CERTIFICATE OF APPROPRIATENESS

Property: 1602 South Boulevard, Lot 9, Block 3, Edgemont Subdivision. The property includes a historic 6,914 square-foot, two-story brick clad single-family residence and a detached garage situated on a 16,900 square foot (100' x 169') corner lot.

Proposal: Alteration – Windows

WEST ELEVATION

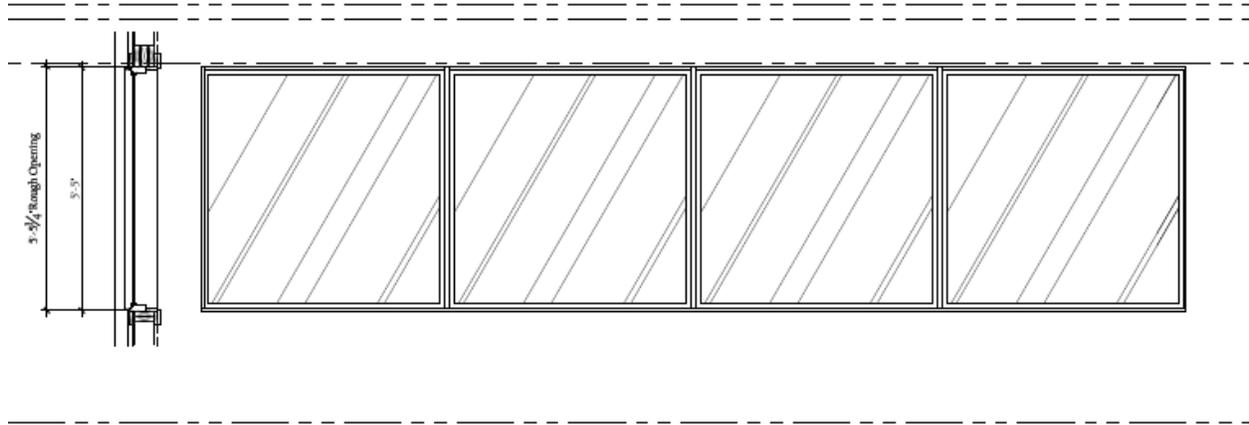
- Side Elevation:** Remove two non-original fixed windows that measure 4' tall by 7' wide on the west elevation on an existing addition and install four grouped fixed windows that will measure 22' wide and 5'-5 ¼" tall. Please refer to drawings.
(West)

EAST ELEVATION

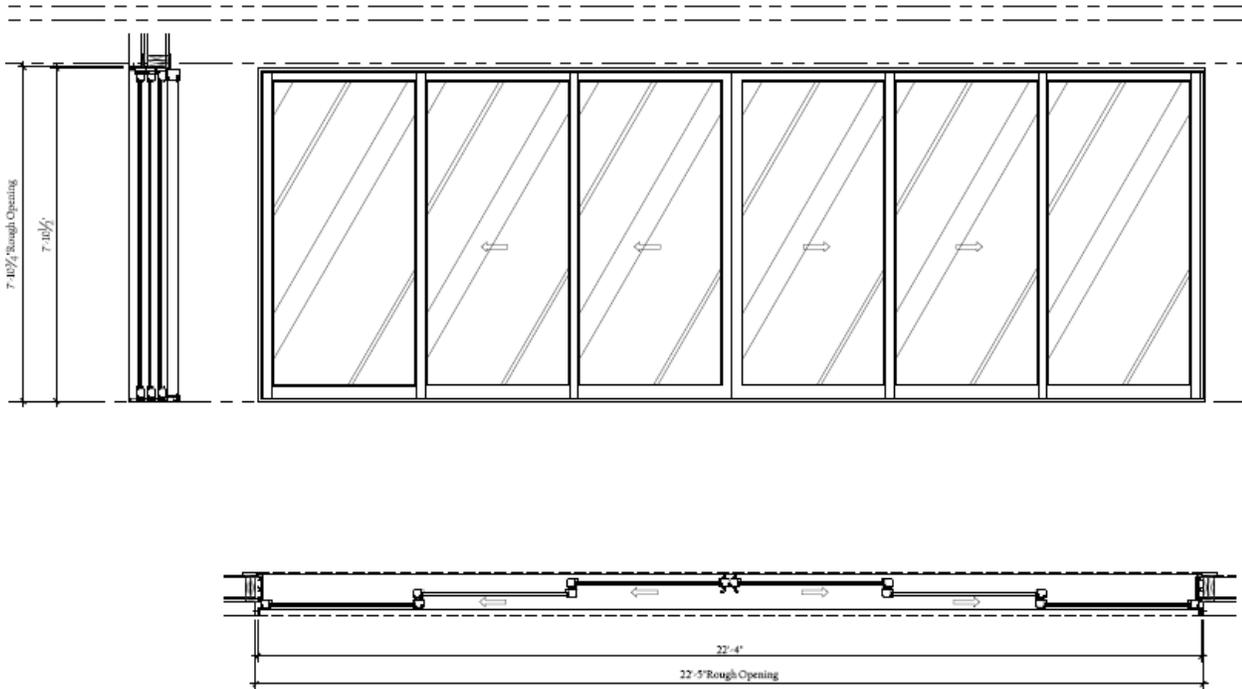
- Front Elevation:** No alterations to the south elevation. Please refer to drawings.
(South)
- Side Elevation:** Remove four non-original windows that measure 4' tall by 7' wide and one non-original door that measures 3' wide by 8' tall on the east elevation and install new glass sliding doors that will measure 22'-4" wide and 7'-10 ½" tall. Please refer to drawings.
(East)
